**WATTS BAR NUCLEAR PLANT (WBN) - UNIT 2 – WESTINGHOUSE EAGLE-21  
PROCESS PROTECTION SYSTEM (TAC NO. MD6311)**

**Enclosure 1**  
**WBN Unit 2 Eagle-21 Request for Additional Information**

Figure 1

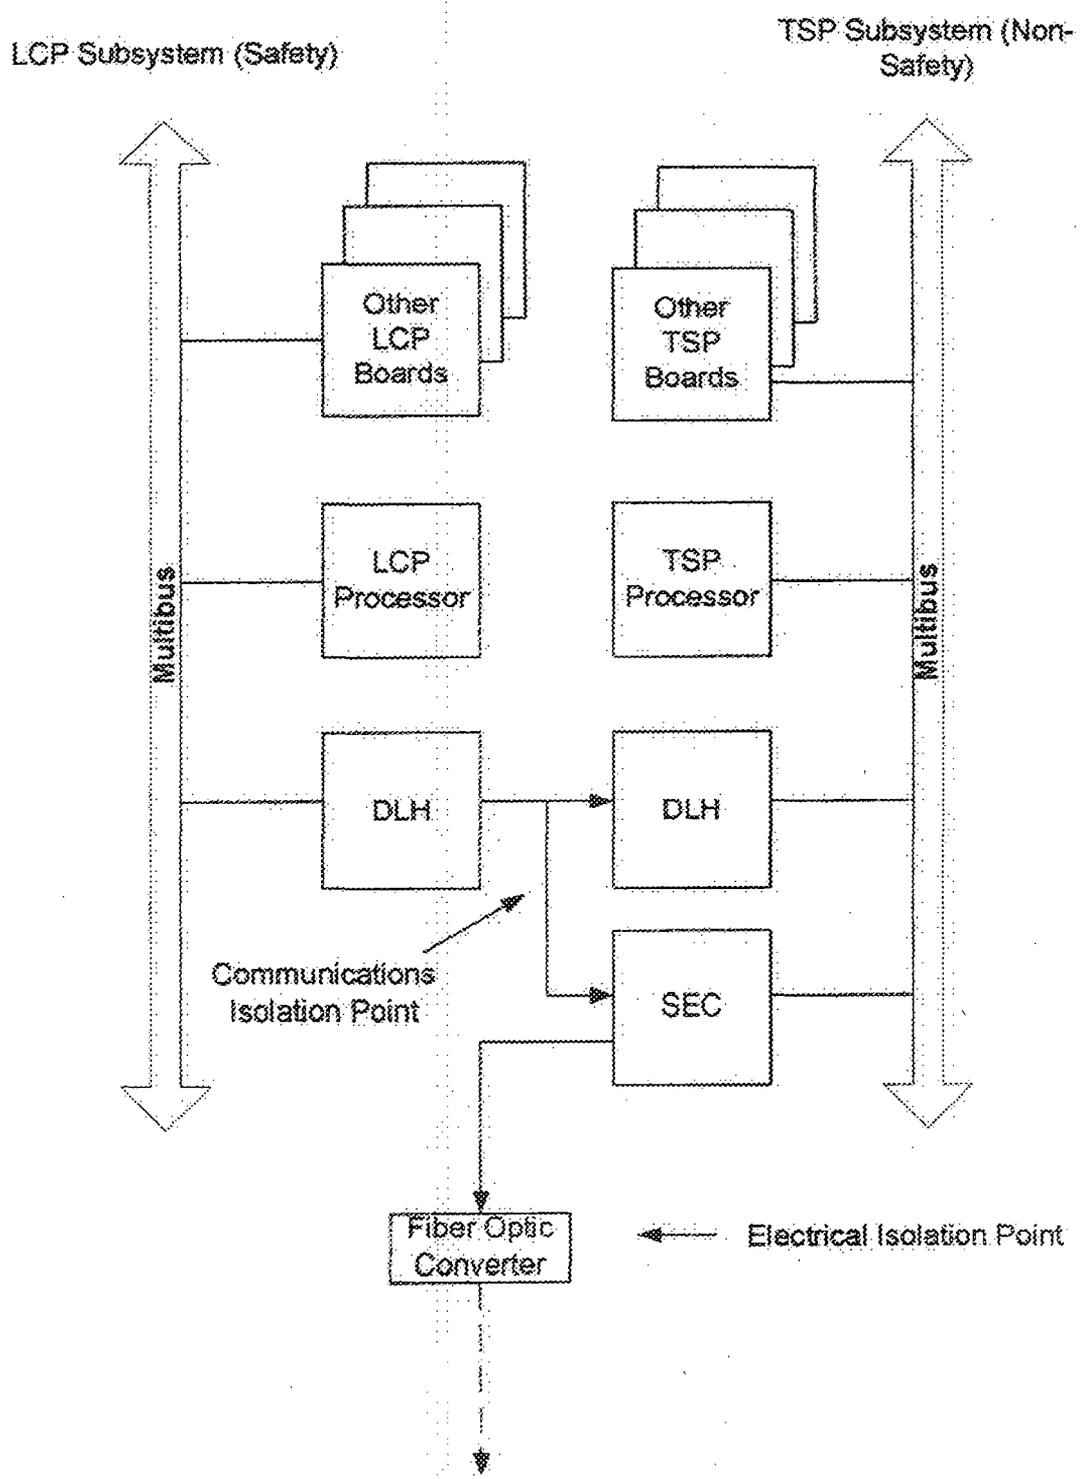
***NRC Question 1:*** On page E1-1 of Enclosure 1 to the February 28, 2008 letter, TVA stated that an external interface was added that included a serial-to-ethernet controller board in each Eagle-21 multibus chassis. TVA further stated that it is not possible for the nonsafety-related integrated computer system signals to feedback to the safety related Eagle 21.

*Has this addition and the associated changes been tested to prove this statement? If so provide the test procedures and test results.*

**TVA Response:** A test to confirm that data cannot propagate from the non-safety Plant Integrated Computer System (ICS) link to the safety portion of the Eagle-21 system was not performed. The rationale is that it is physically impossible for such a propagation to occur. The Serial Ethernet Controller (SEC) board which interfaces with the ICS link receives data by passively listening (i.e., receive only, no handshake) to the Loop Control Processor (LCP) (safety portion of system) to Test Sequence Processor (non-safety portion of system) datalink. The LCP Datalink Handler card which is transmitting the message is a one-way, broadcast communication link and has no receive capability. The SEC board only uses the Multibus bus connection for power and is installed in the non-safety tester portion of the Eagle-21 system. Thus there is no data connection that would allow data transmission between the non-safety ICS link and the safety portion of the Eagle-21 system. The design meets the requirements of IEEE Std 7-4.3.2-1993, "IEEE Standard Criteria for Digital Computers in Safety Systems of Nuclear Power Generating Stations," Annex G, for safety to non-safety communications. Figure 1 shows the electrical and communication isolation points.
